M25 junction 28 improvement scheme

8.1 Statement of Common Ground with the Environment Agency

8.1 STATEMENT OF COMMON GROUND WITH ENVIRONMENT AGENCY

Regulation Number:	Regulation 5(2)(q)
Planning Inspectorate Scheme Reference:	TR010029
Application Document Reference:	TR010029/APP/8.1
Author:	M25 junction 28 improvement scheme project team, Highways England

Figure 1 – location of components affecting water environment

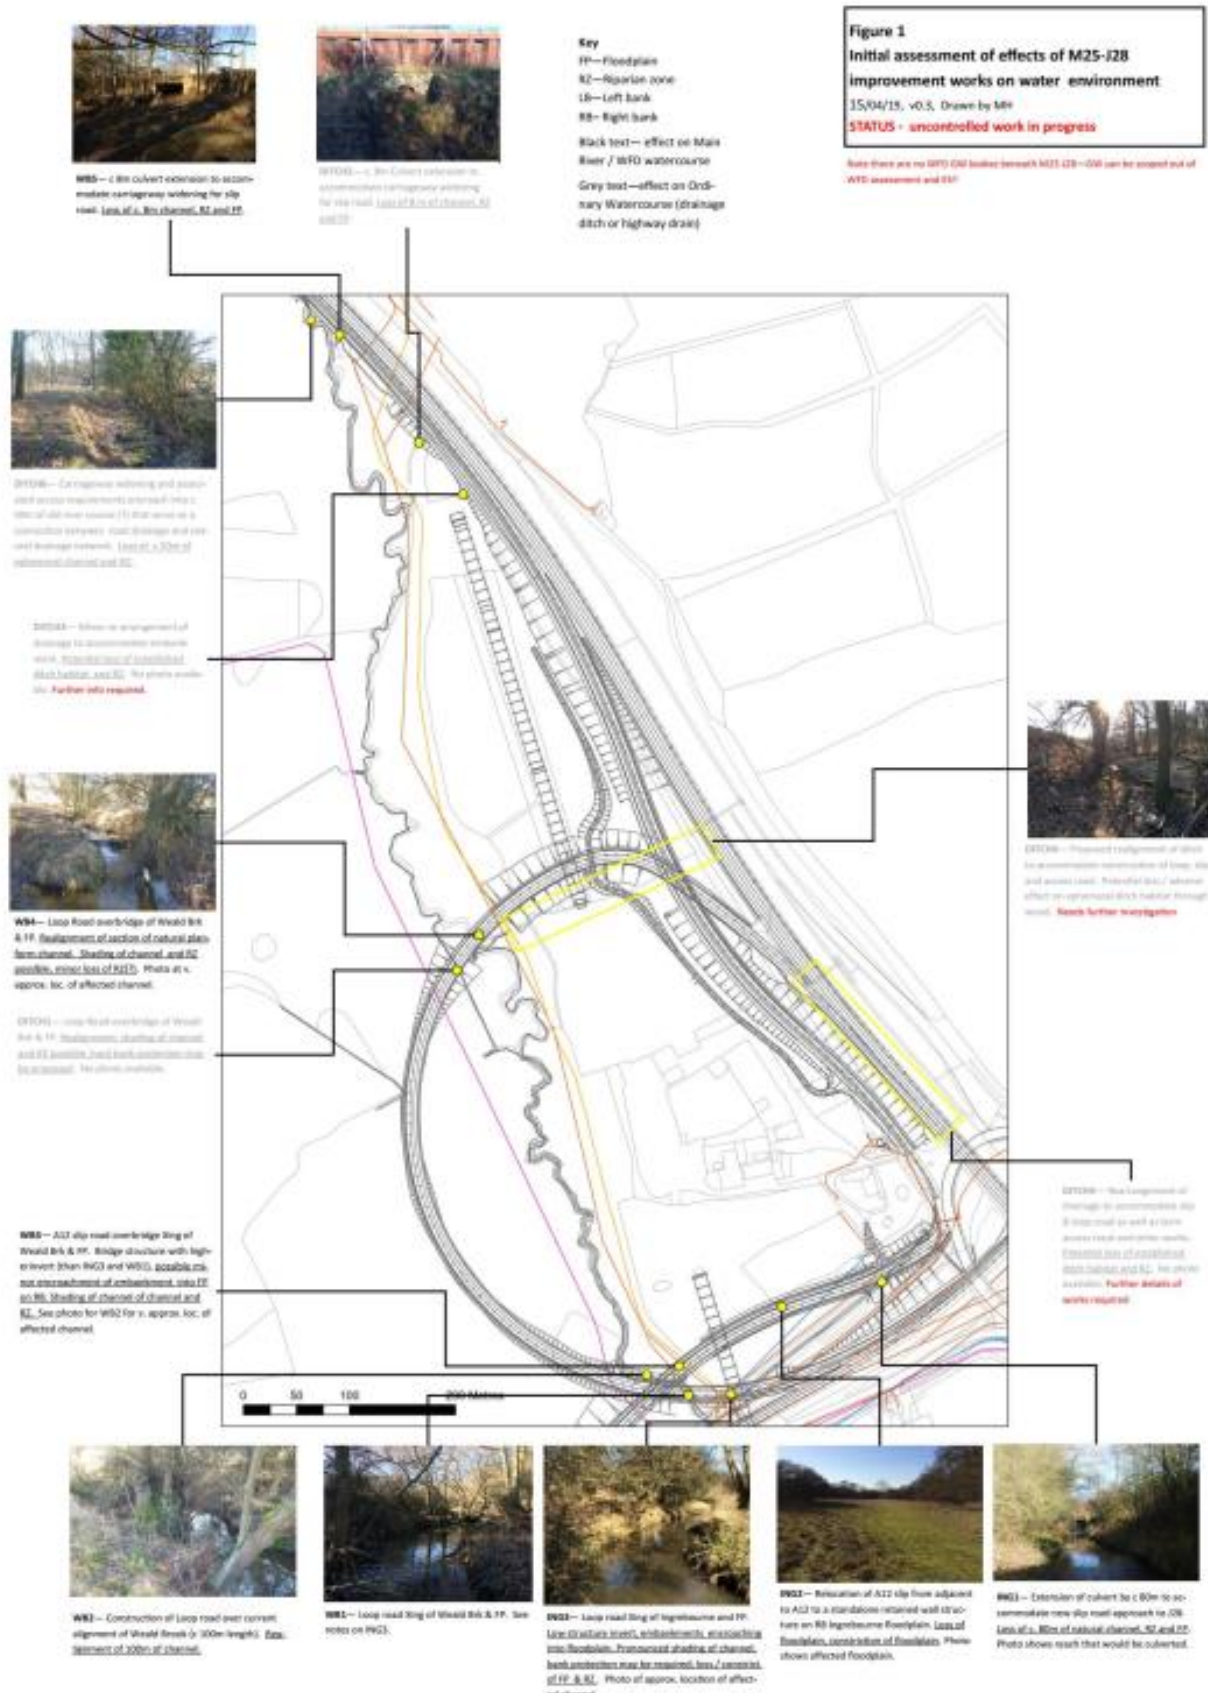
Scheme component (see fig. 1)	Name	Discussion points
	Brook and FP	<ul style="list-style-type: none"> o EA asked if Atkins can investigate retaining the upstream two meanders in the proposed realignment (Action [REDACTED] – look into this design change) o EA generally happy with proposed mitigation – restoration of a similar length of existing straightened channel to more natural form
WB5	Culvert extension on M25 Weald Brook Xing	<ul style="list-style-type: none"> o Discussed briefly. Principles set out in "Initial thoughts from EA" for ING1 apply (though obviously at a much smaller scale, given the 8m extension here). (Action [REDACTED] – update mitigation, given that existing proposals are not adequate – can probably be included into proposed restoration elsewhere on Weald Brook)
Ditches		Not discussed at meeting (of lesser significance than effects on main river)

MIT4a,b,c	Within the restrictions defined by other constraints (most notably services, road safety and cost) structures have been set as high and wide as feasible.						Y	Y								
COMP1	Realignment of Ingrebourne, creation of backwaters, reconnection of floodplain.	Y	Y	Y	Y											Base width of channel is taken as 1m. Bankfull width taken as 9m. Channel is typically 1.5m deep
COMP2a,b,c	Ground lowering to increase floodplain storage.		Y	Y	Y											
COMP3	Riparian zone tree works to create varied light intensity, either by selected tree removal / coping or tree planting, depending on conditions.			Y	Y		Y	Y	Y							Strategic tree felling / planting to vary intensity of light reaching river and riparian zone. Different light intensities encourage different habitats.
COMP4a-e	Floodplain wetting by retaining natural surface water drainage on floodplain, or lowering floodplain.			Y	Y				Y							Wetter floodplain created by a) reducing the rate (or preventing) water draining to the river or b) scrapes to lower floodplain. Limited earth movement anticipated.

COMP5	Channel realigned with natural cross section. Additional realignment / restoration of planform of modified channel further upstream.					Y		Y								
COMP6	Realignment of c. 40m of drainage ditch into naturalised channel with scrapes.									Y						
COMP7	Restoration of planform of modified channel further downstream. Backwaters at Crossing.							Y								
COMP8	Floodplain scrape to create wetland area.										Y					
COMP9	New backwater created, returning to river 20 m downstream.														Y	
COMP10	Floodplain scrape to create wetland area.							Y								
COMP11	Floodplain scrape to create wetland area.									Y						
COMP?													?	?

Figure 1 Ingrebourne River (French's Farm)

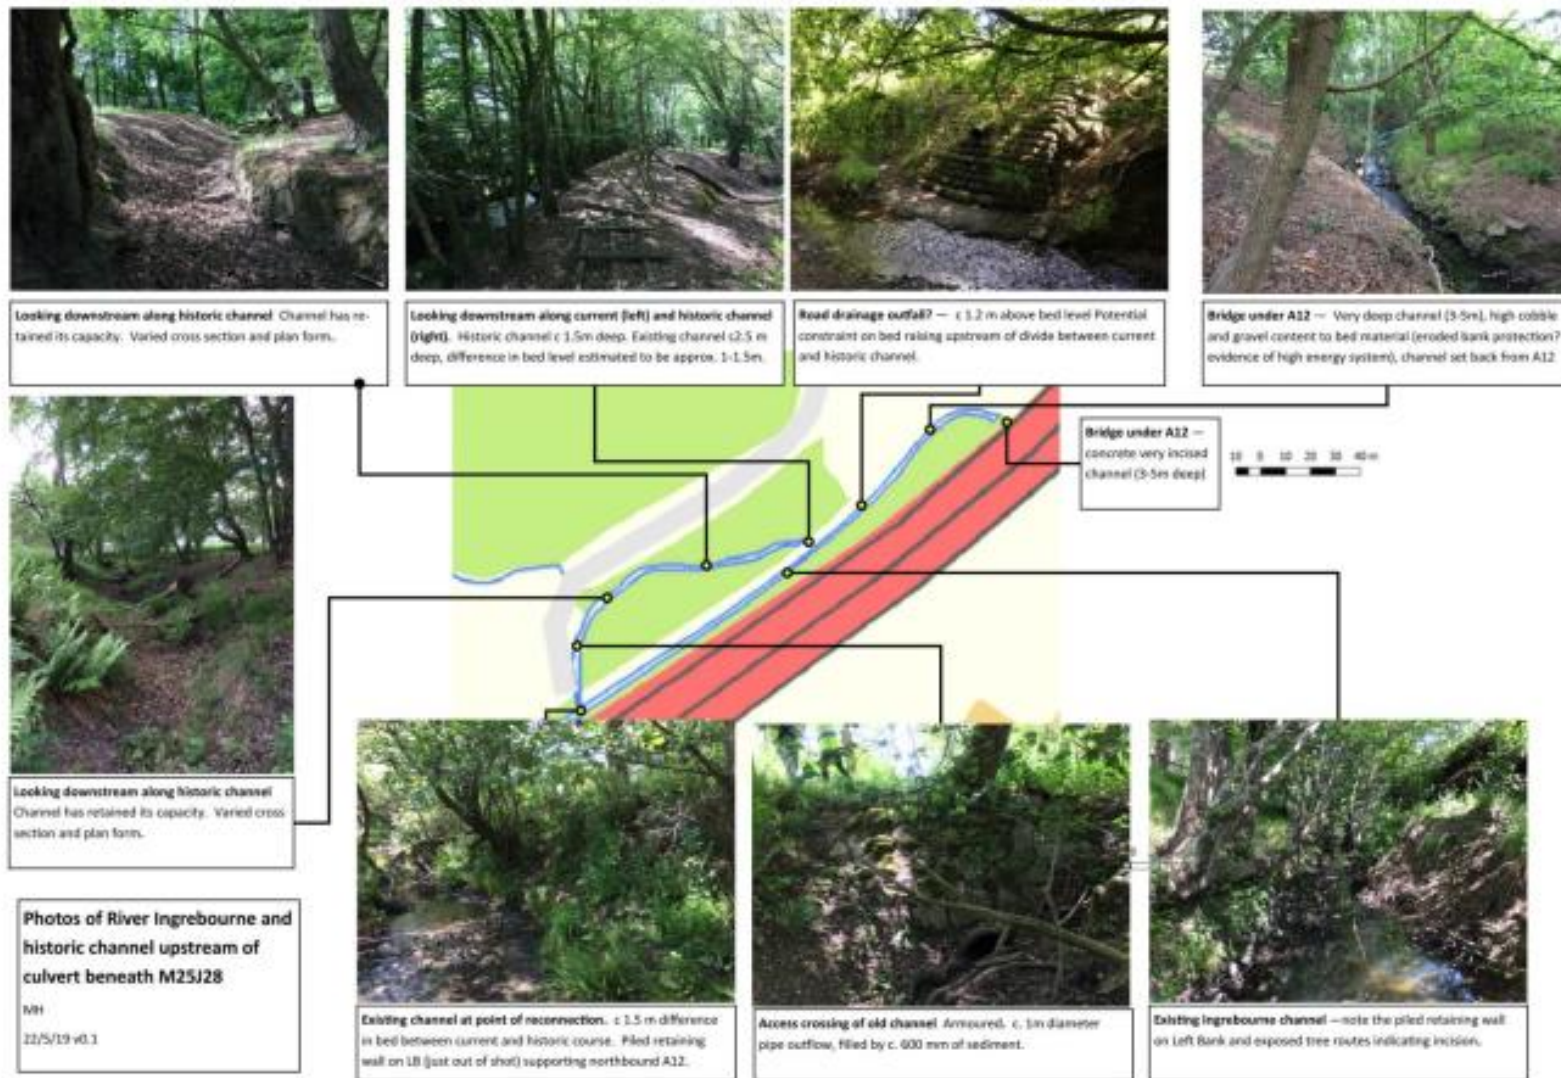
Natural geomorphological process has re-established limited sinuosity and complexity in channel cross sectional and long sectional form. For instance, along reaches with trees, incision has exposed roots and boughs of trees, creating habitat complexity. Where incision has been into mineral material, complexity has been created by deposition of side bars and runs with a substantial gravel content (see photos in Figure 1).

For this reason, the consensus during the site visit was that there was minimal ecological benefit to installing in channel restoration features along this reach of the Ingrebourne. Restoration features will achieve little more that is already developing naturally, given the substantial constraints of the deep and steep channel.

Figure 3 Action straw doll conceptual design schematic

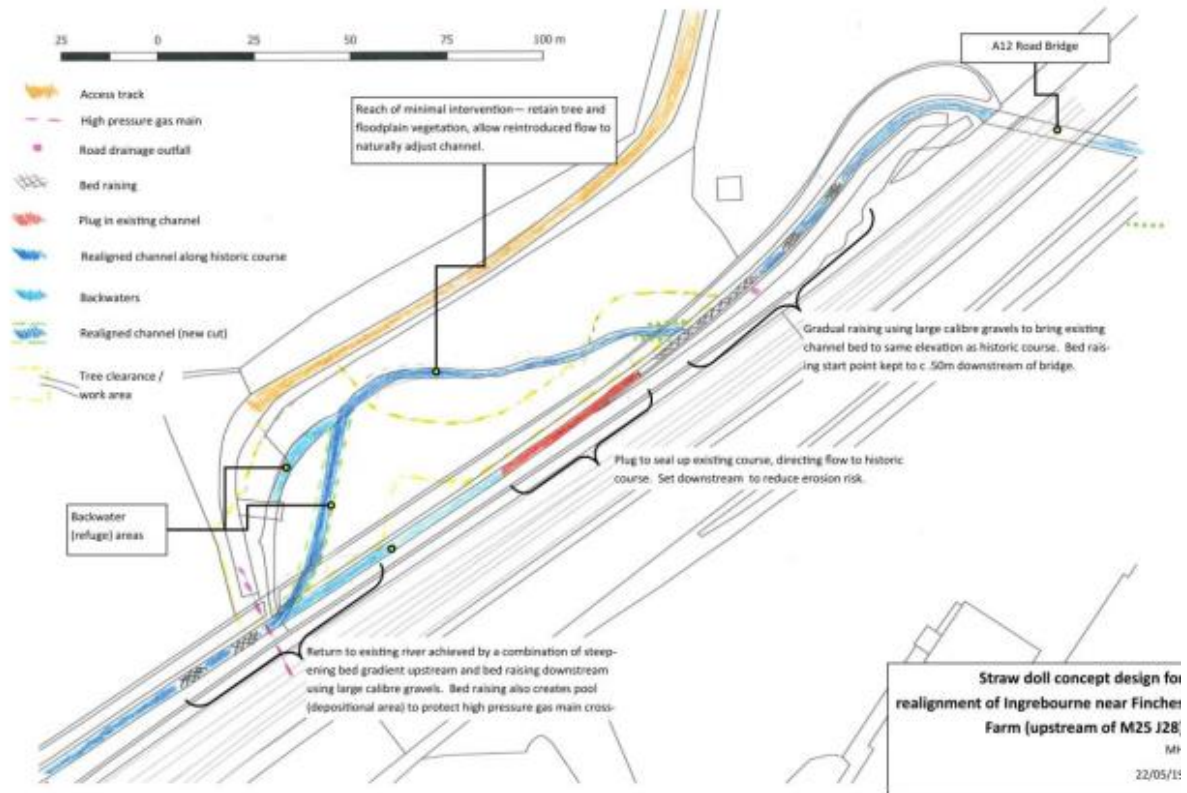
A conceptual design based on discussions during the field visit presented in Figure 3. This is intended as a starting point and a trigger for discussion on determining feasibility of this intervention

Potential works identified during telcon of 11/220 (locations approximate)

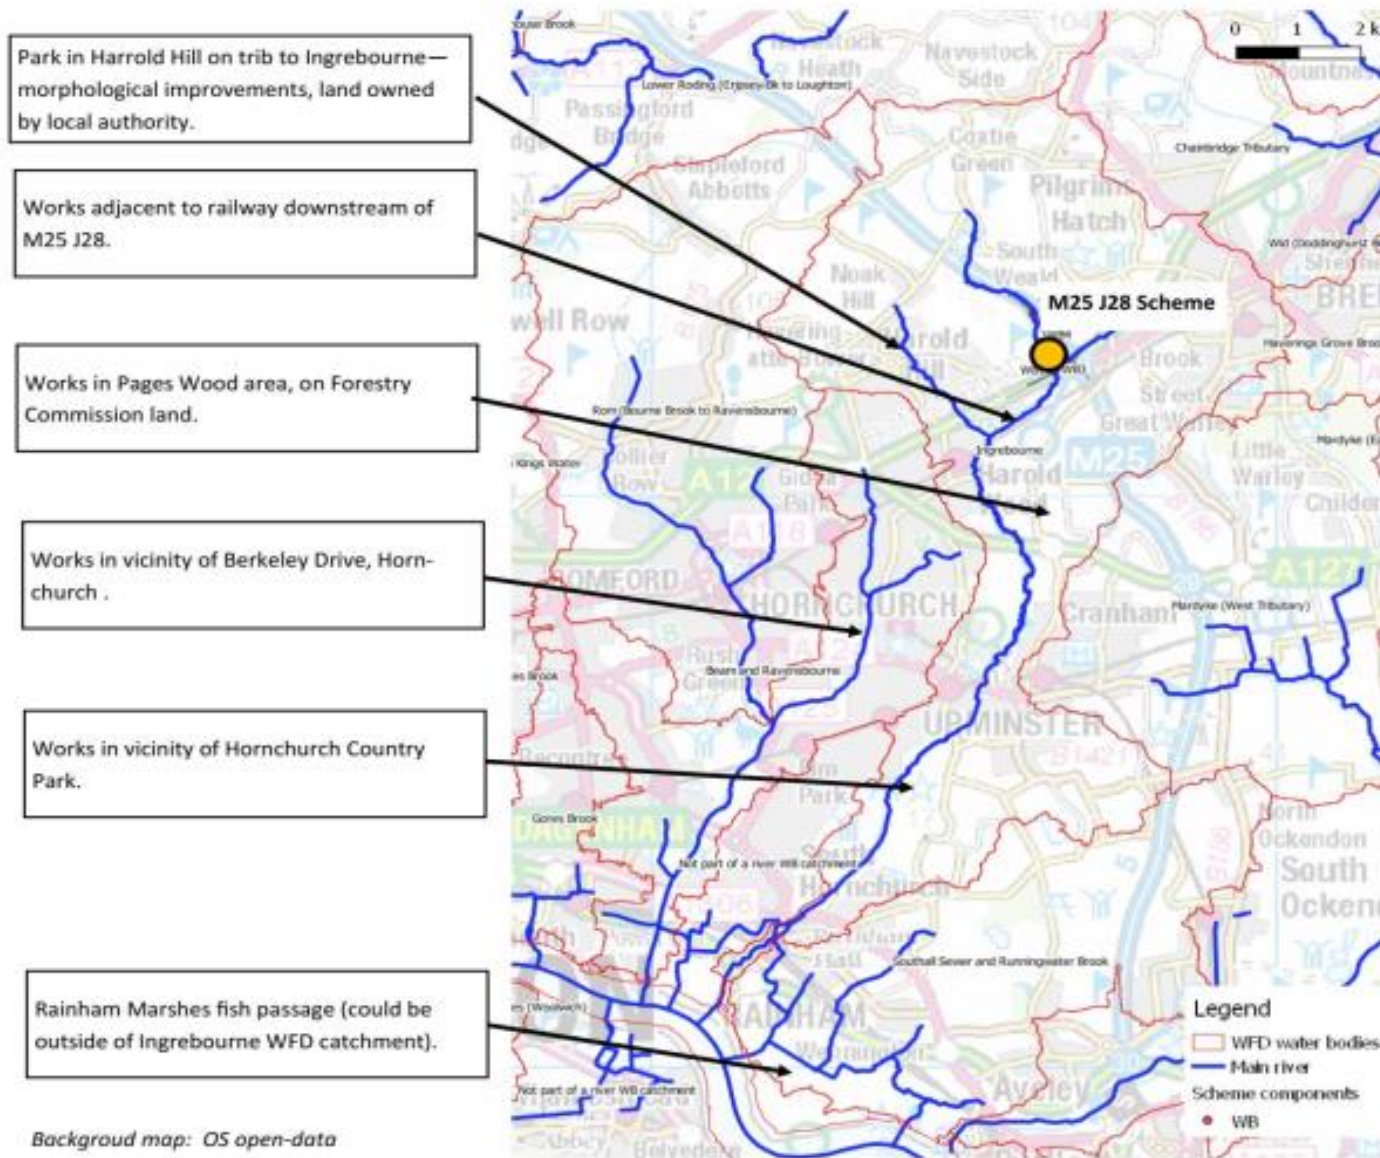
3.	<p>Discussion on potential locations of measures</p> <p>Location of potential measures (called works in this note) within Ingrebourne WFD water body identified during telcon show on attached plan (rough locations).</p> <p>EA planning windscreen survey / walkover of key areas of Ingrebourne catchment to identify potential river / floodplain improvement works – some could be candidate sites for off-site compensation for J28 Scheme.</p> <p>Local Authority 'forum' being organised for the J28 Scheme to bring together appropriate specialists from the J28 project team and local authorities to address key issues such as consenting. Off-site compensation will be included as a topic for the forum. EA welcome to attend the forum, particularly on this issue, either in person or by telcon. Provisional date 3rd March 2020.</p> <p>Landowner appetite for river improvement works will always be a fundamental constraint – this risk can be managed by identifying works on land owned by aligned partners (e.g. local authorities and Forestry Commission) and identifying multiple river improvement works, in the expectation that some will fall by the wayside because landowners are unable to provide support.</p> <p>In summary – EA team were positive about being able to identify a sufficient number of candidate river improvement works within the Ingrebourne WFD body but needed some time to investigate further before being able to commit to this.</p>
